Author's Reply to Anonymous Referee #1

High current speed events in a harbor channel driven by resonant sub-hourly sea level dynamics: an example from Varna, Black Sea

RC1: 'Comment on egusphere-2026-1731', Anonymous Referee #1, 03 May 2026

Author's Reply to Anonymous Referee #2

Fig01

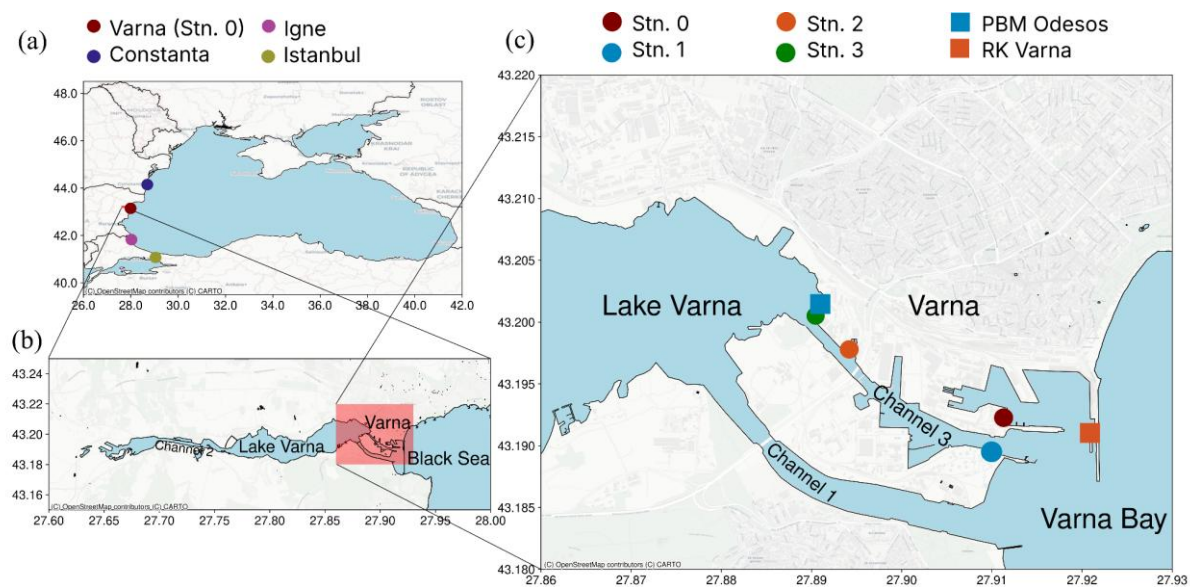
L102-104 (Figure 1): What does PBM and RK stand for in the subplot (c)? Is the date for last visit the link in the caption needed here?

Reply: The caption of Figure 1 is extended to note that the observations shown in the subplot (c) are presented in Table 1. Regarding the link <https://marine.copernicus.eu/> we think it is not necessary to present the date of the last visit, since we do not present any sub-link to the parts of the Copernicus Marine Service, which is a permanent activity.

Figure 1. (a) Location of the study area, shown on the map of the Black Sea. The western coastal stations where data are shared within the Copernicus Marine Service <https://marine.copernicus.eu/> are indicated on the map. (b) Map of the Varna region. (c) Map of the study area displaying the locations of the observation sites. Details of observation points are given in Table 1.

Fig02

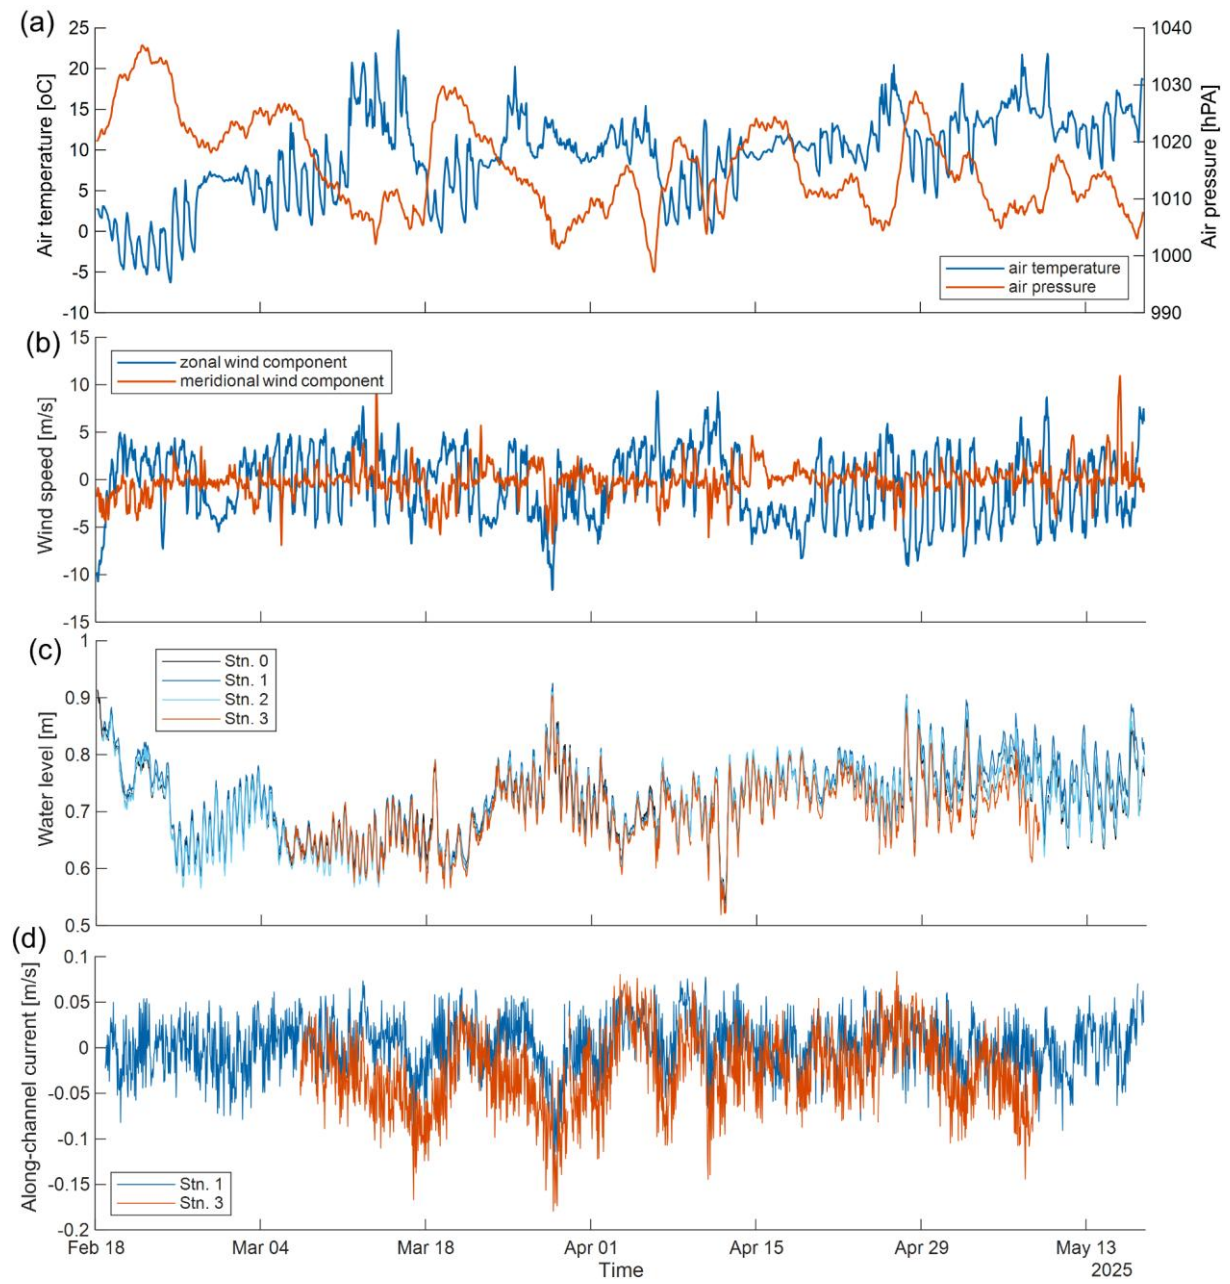
L172-173 (Figure 2): From which station are the measurements in pane (a) and (b)? Why are only Stn. 1 and Stn. 3 presented in (d) and not Stn. 2? Also, there is no need to write the x-label at all subplots since they have the same x-axis, this will save some space. Furthermore, I don't know if the figures are of good quality since inserted into the text, they seem a little bit blurry but that can be the result of rendering. This, and also other, Figures have a secondary x-axis, which means in MATLAB, that the year is lower than the ticks. This is not the problem when everything is clear, but since you have 4 subplots here the extra space, that you would save if you turned off the x-axis labels for all but the last subplot is large. Ticks can be switched off because you have the same x-axis for all plots.

**** Since the water-level difference between the two ends of the channel appears to be the primary driving mechanism, it would be useful to present this parameter together with the measured currents. For example, the water-level difference (Stn3–Stn1) could be included as an additional axis in Figure 2 to facilitate interpretation of the current response.**

Reply: We have redrawn the figure as recommended. Regarding Stn. 2, the data showed similar general current-velocity patterns to Stn. 1 and 3, but it is not included in panel (d) because the current-velocity measurements at times exhibited drift and were considered less representative of the channel flow. This was most likely due to mechanical and/or magnetic disturbances at the sensor location. To avoid over-interpreting measurements with potentially more uncertainty, only the results from Stn 1 and 3 are presented for the velocity. The figure caption was reformulated to:

Figure 2. Time series of meteorological and oceanographic data with 1-hour resolution. (a) Air temperature and air pressure, (b) zonal and meridional components of wind speed, (c) water level and (d) along-channel current speed (positive from lake to sea). Data from RK Varna (a, b), stations from Stn. 0 to Stn. 3 (c), and Stn. 1 and Stn. 3 (d).

In the hourly data as shown in Fig. 2, the water level difference Stn3–Stn1 (the curves shown in Fig. 2c) was small and not directly related to the along-channel currents shown in Fig. 2d. By linear theory, the wave period T and wavelength λ are related as $\lambda = cT$. Adopting phase speed $c = 10 \text{ m s}^{-1}$ and period $T = 10^4 \text{ s} = 2.77 \text{ h}$, the wavelength $\lambda = 10^5 \text{ m} = 100 \text{ km}$ is much larger than the length of the channel. Therefore, in the low-frequency band, the channel flows were driven by the seaside water level, without significant local wave effects.

Fig03

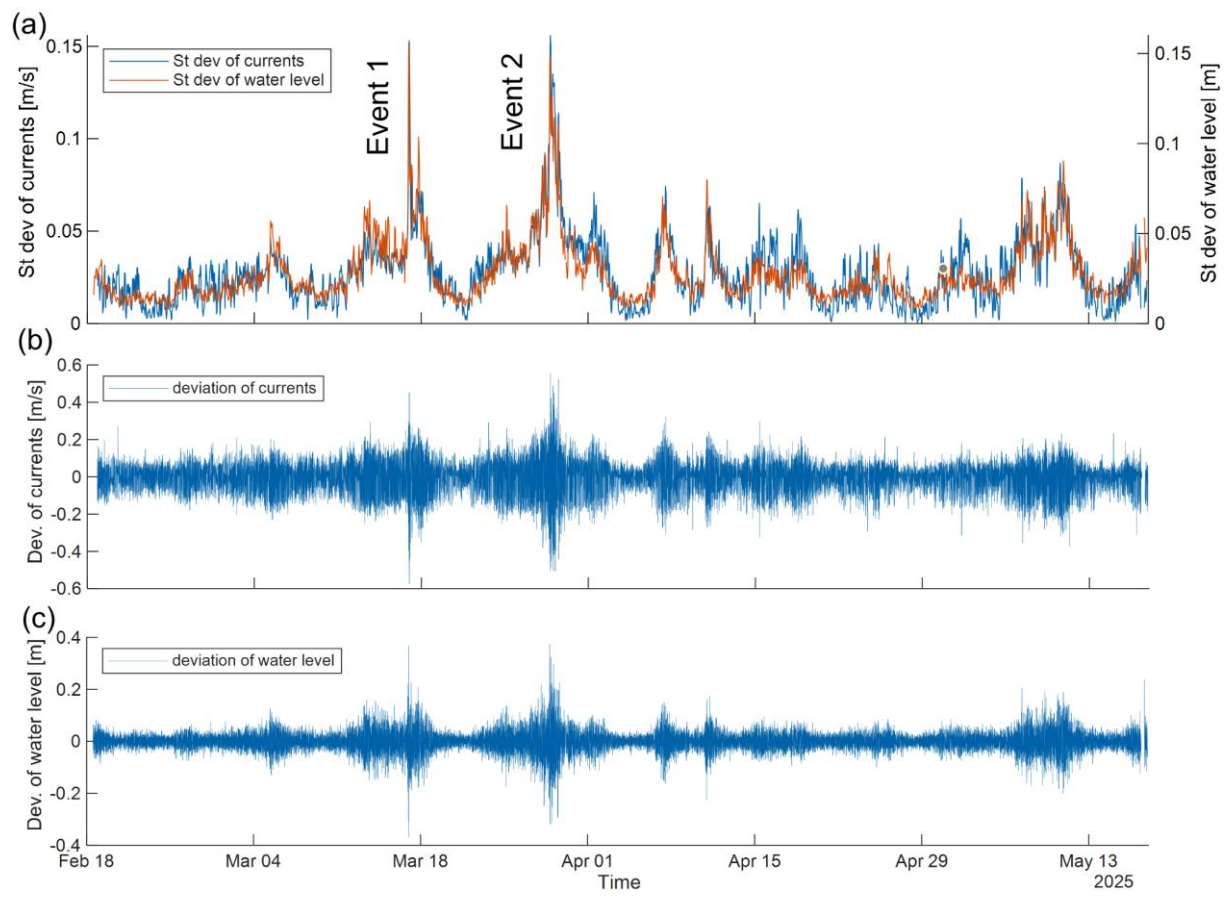
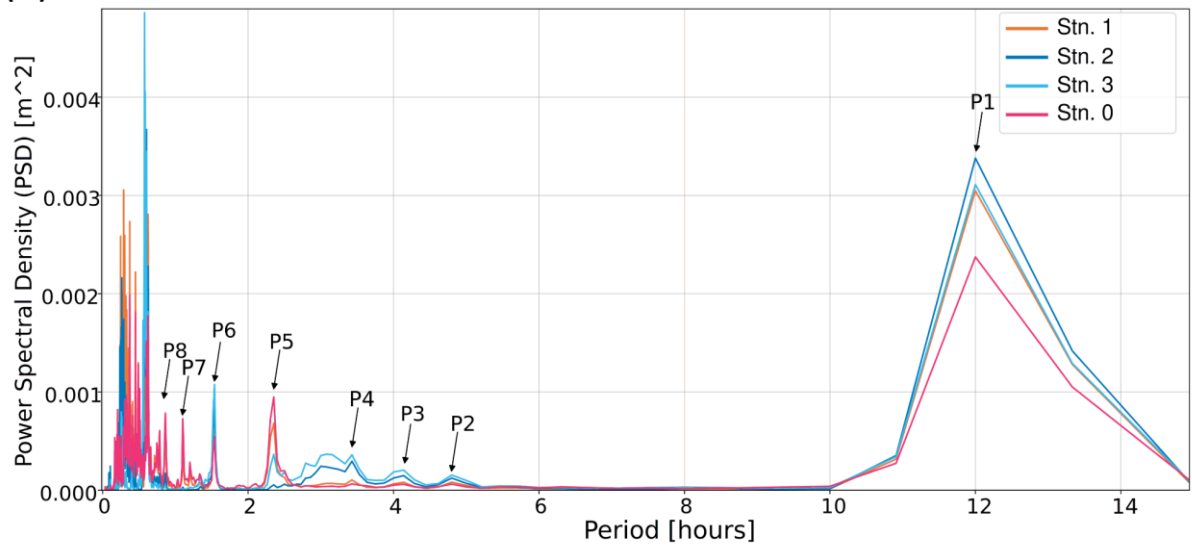
L241 (Figure 3): Same for x-label as before and for the titles of subplots...

Reply: We have redrawn the figure as recommended.

Fig04

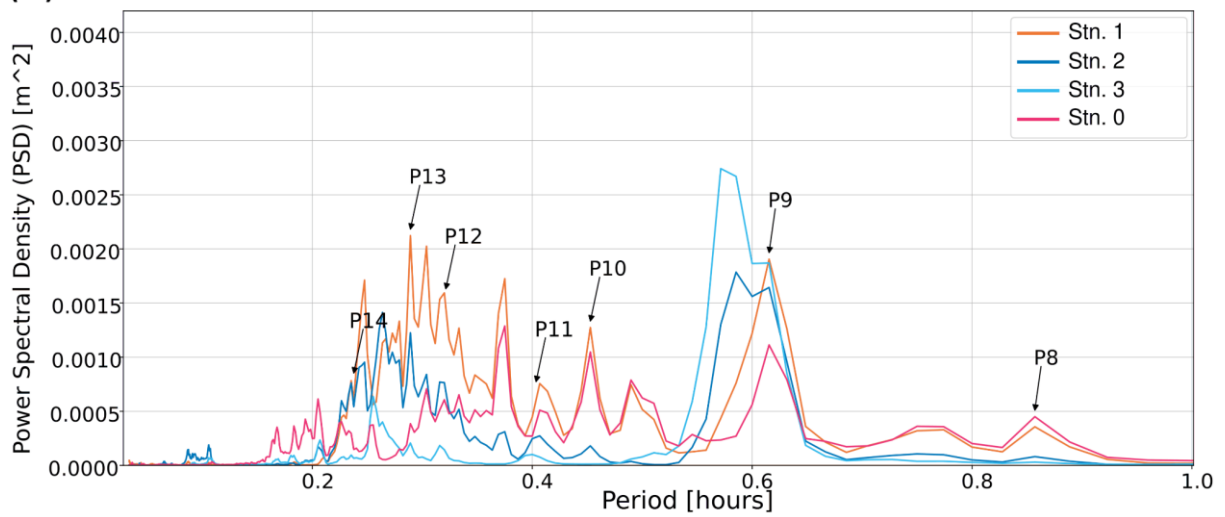
L257-258 (Figure 4): It would be clearer to note (a) than say what is presented in (a), than (b) and than what is presented in (b) not the caption first and letter of the subplot later. Also, the size of the font is really small. The y-label is not readable.

Reply: We have redrawn the figure as recommended and have rewritten the figure caption.

Figure 4. (a) PSD of water level at the four measurement sites of the channel in the range of periods from 2 min to 15 h using a 6-day Welch segment. (b) PSD for periods from 2 min to 1 h, computed using a 1-day Welch segment length to better resolve higher-frequency variability.

Fig06

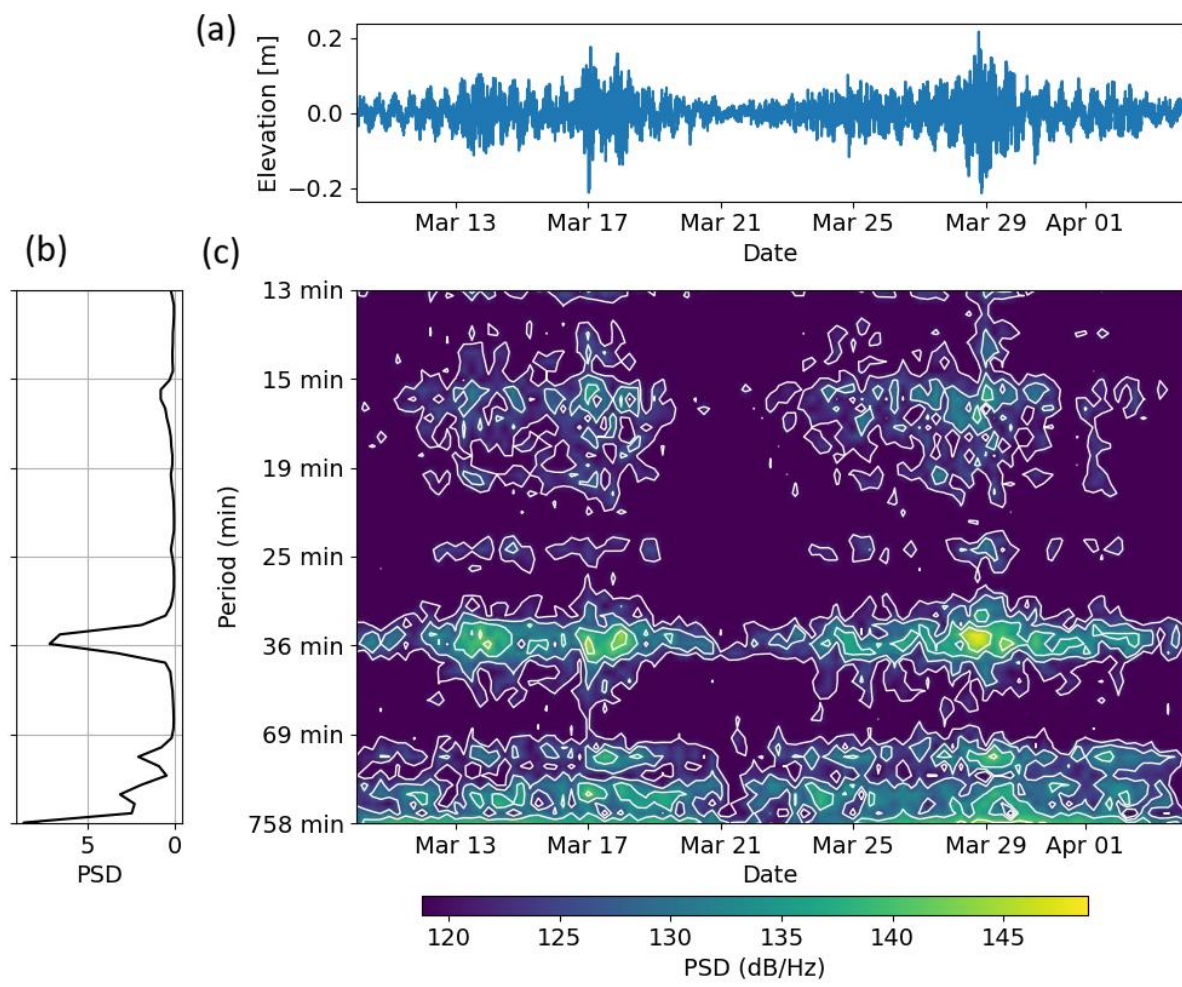
L290 (Figure 6): The titles of the subplots seem redundant since everything is explained in the caption - the titles only add more clutter to the plot. Everything else is the same as for most other Figures... small font, etc.

Reply: We have redrawn the figure as recommended.

Fig09

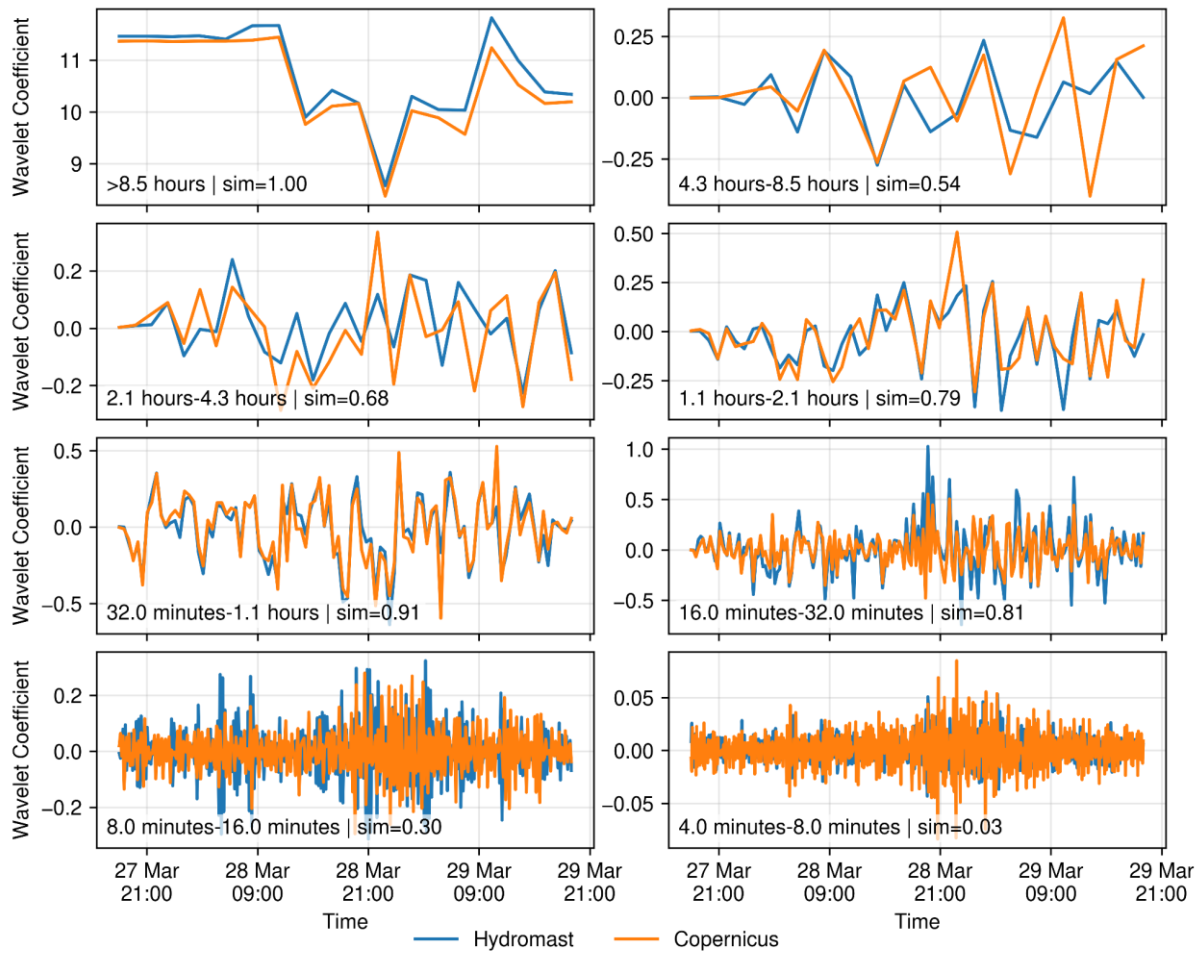
L320 (Figure 9): Very poor quality of Figure 9. X-axis is very bad, in some instances the ticks overlap - last row of the Figure. There is also a lot of empty space between subplots.

Reply: We have redrawn the figure as recommended.
